February 7, 2022 Planning Commission City Hall - Massie Chambers
5:00 PM

CITY OF GOODLETTSVILLE PLANNING COMMISSION

ITEM#3 IFP Realty, LLC /AZIM Tech Engineering: Requests site plan approval for a 12,000 sq. ft. office and service center on 1.52 acres on Windsor Green Ct. Property is zoned GOPUD, General Office Planned Unit Development and is referenced as Davidson County Tax Map/Parcel# 026060B02400CO. Property Owner: IFP Realty, LLC (#1-22)

SHEET TITLE PARTIAL SITE PLAN, EQUIPMENT LAYOUT	
DRAWING NUMBER E4	
THIS DRAWING IS 11"x17" AT FULL SIZE	
SITE ID: 1141	SHEET 6 OF 12

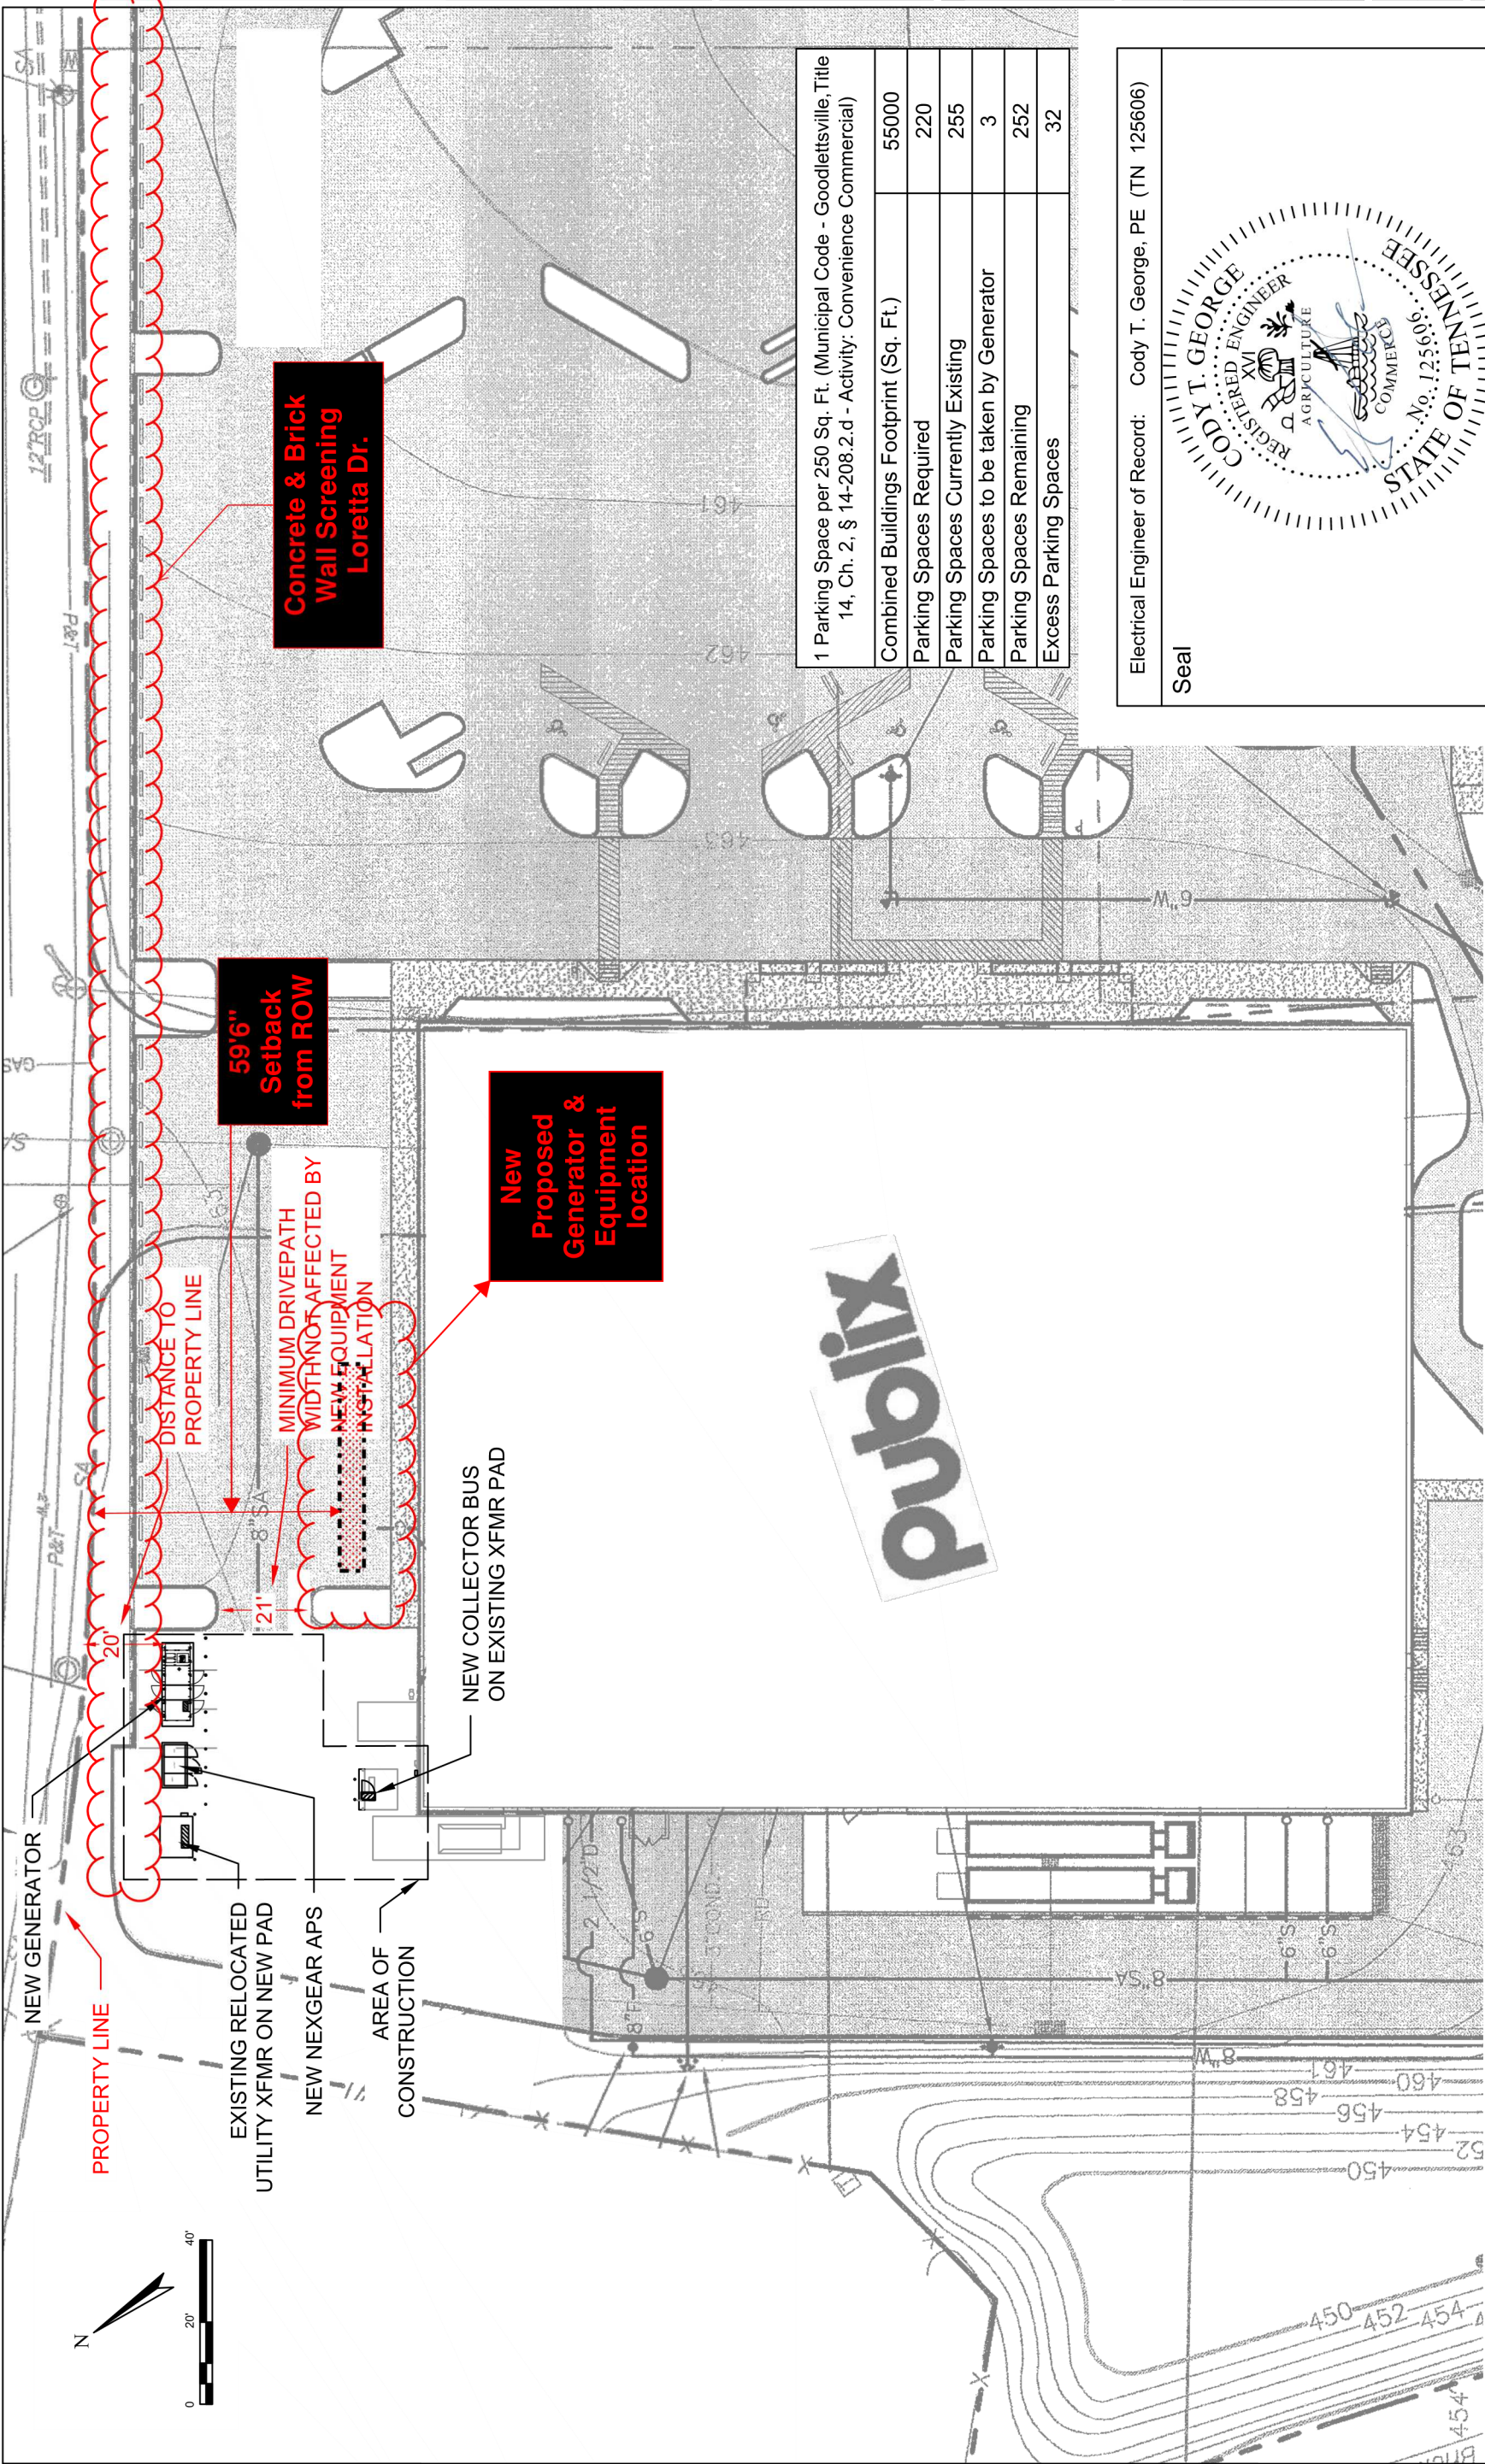
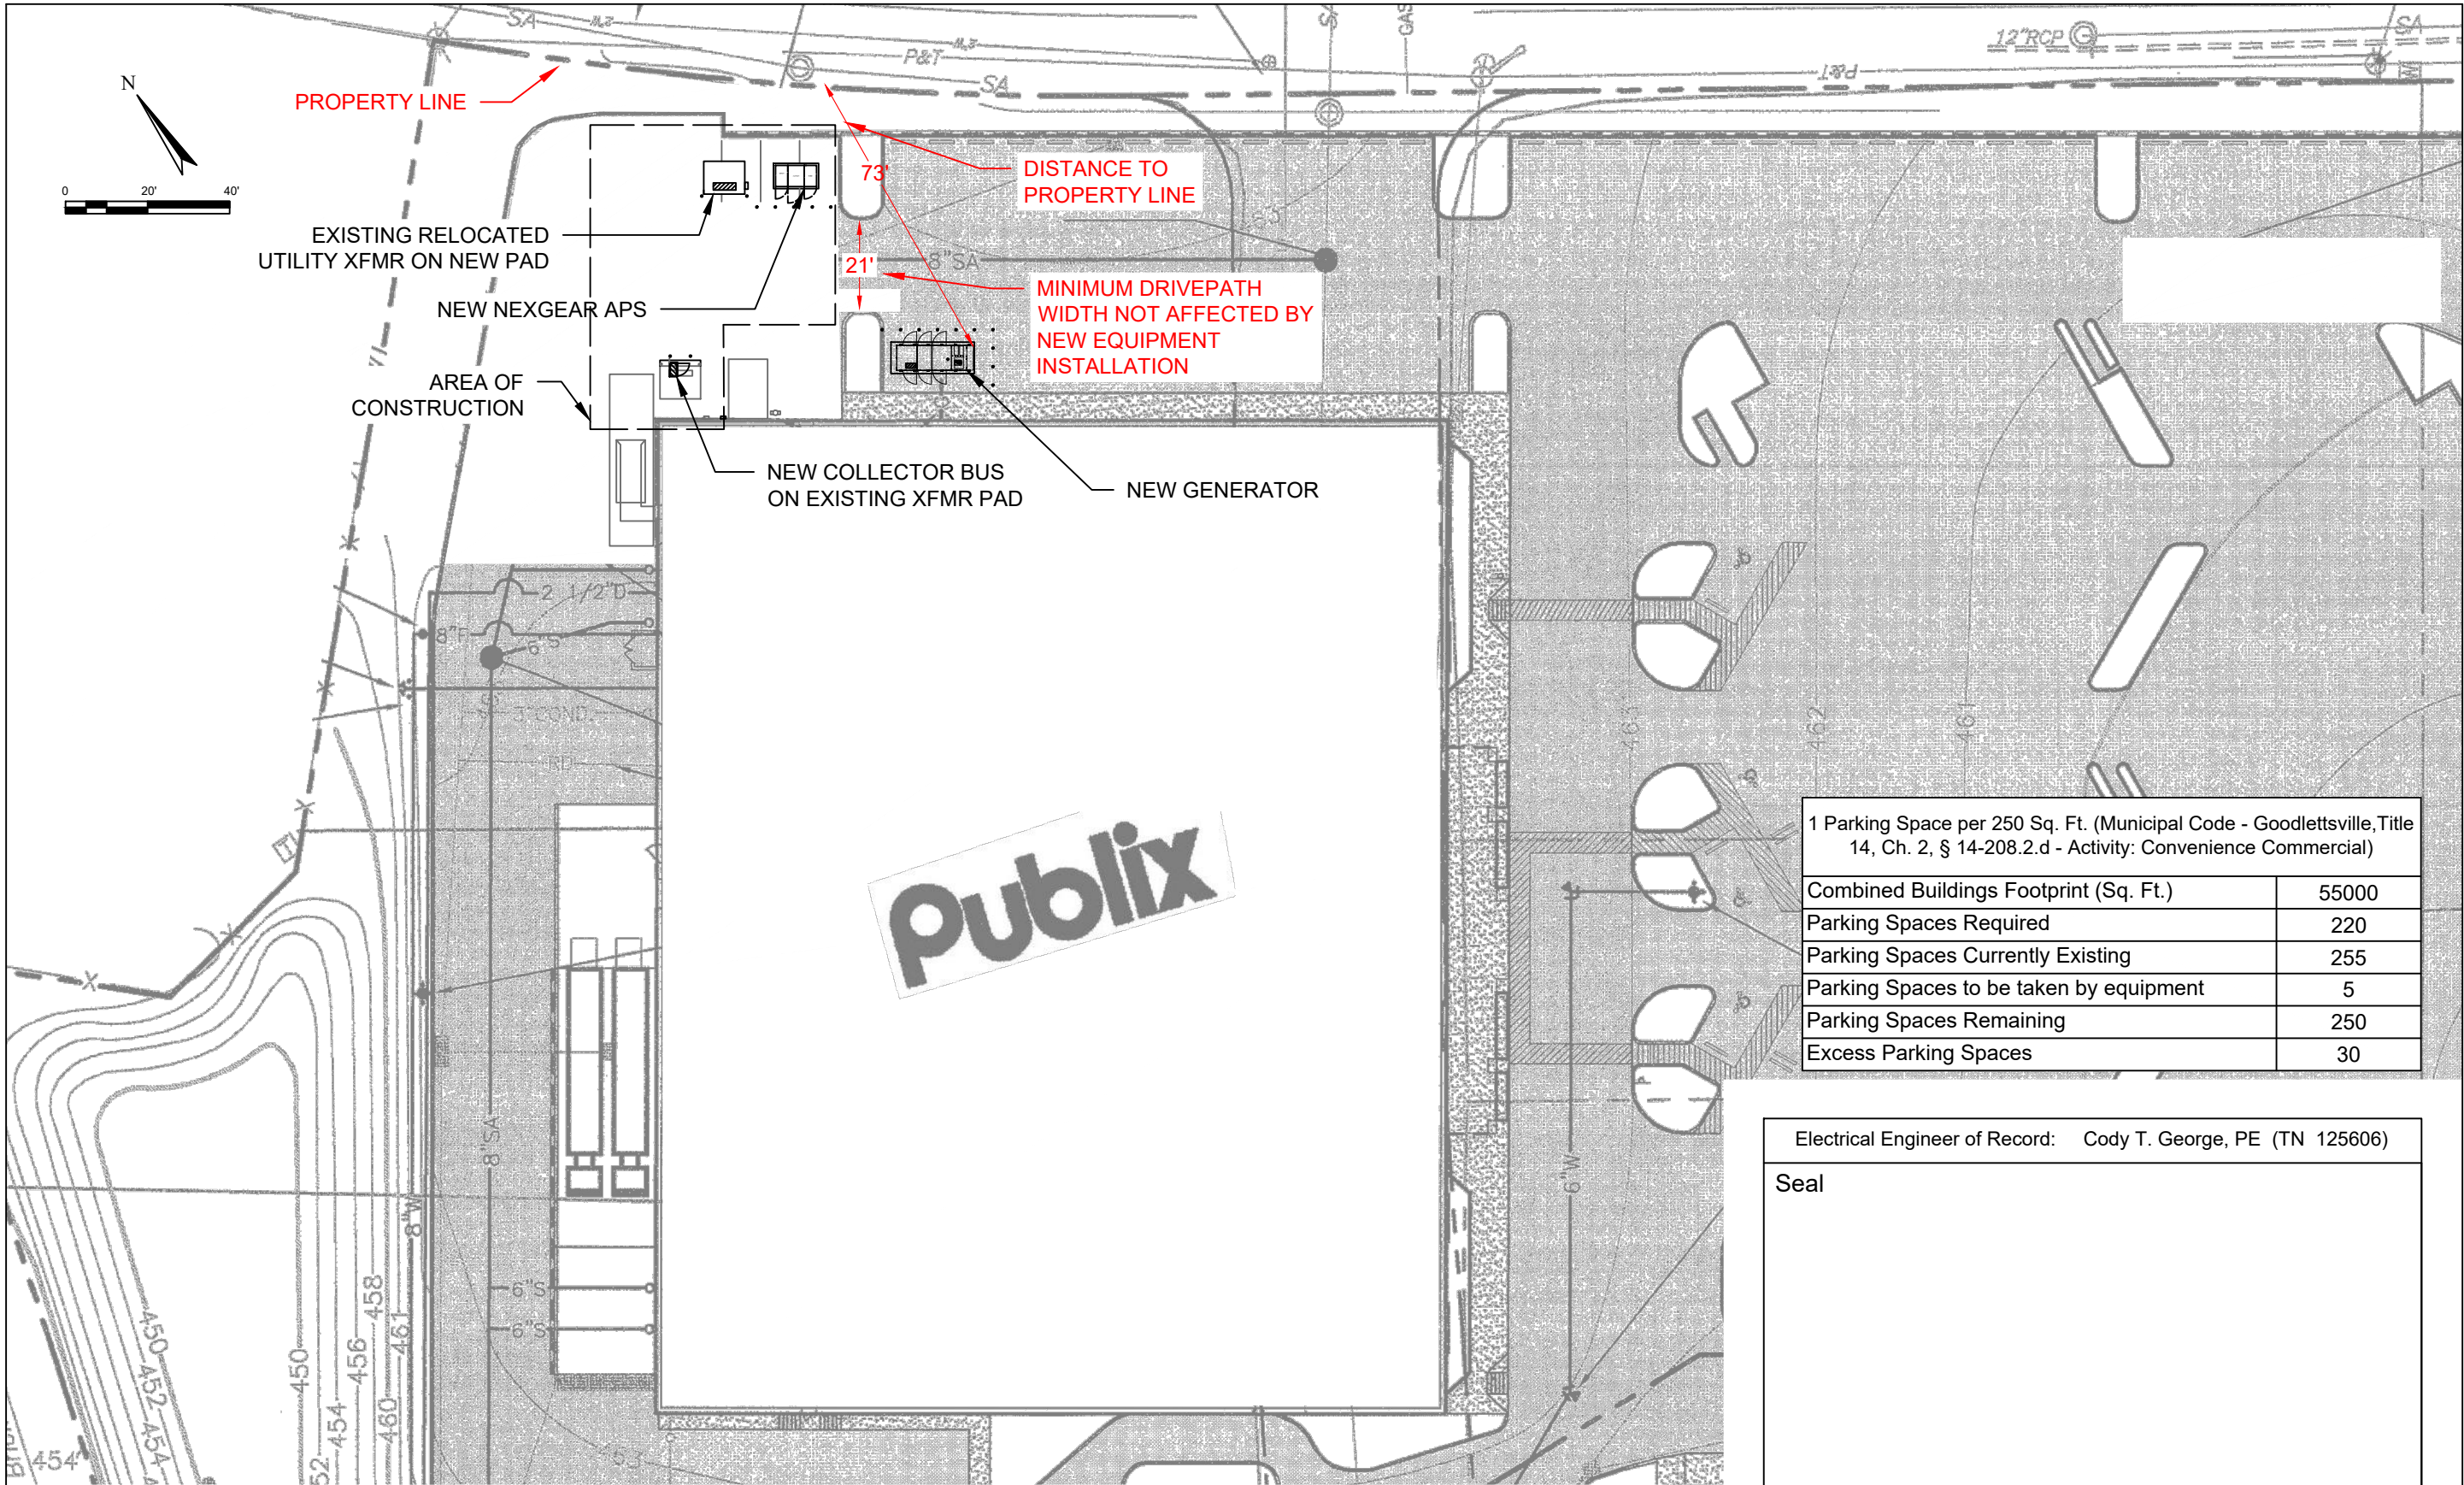
The request is for an additional emergency generator to be installed for expanded generator operating capacity. The request would be a minor master plan amendment proposal. The proposed additional generator is on the north-east side of the building along the existing side parking lot. The proposed generator would include reduced parking as shown on proposed plan, but the proposal would not create a minimum parking violation for the Publix center. During the initial review of the proposal, staff requested a type of screen wall along the side of the proposed generator due to increased visibility of the proposal. The applicant originally requested the generator to be along the perimeter parking spaces in this area (initial plan attachment) but based

on the proposed diesel fuel tank with the generator, the City's Zoning Ordinance requires the fuel tank to be located outside the front yard. Per the CPUDL, Commercial Planned Unit Development Limited zoning and project master plan the front setback is forty (40') feet off the Loretta Drive right-of-way. The Planning Commission in review of alterations to master plans in planned unit development zoned properties may review variances or alternatives to zoning requirements.

STAFF RECOMMENDATION: Per original staff request, approval of proposal with a type of screen wall between the proposed generator and adjacent parking area and the revised generator location along the building.
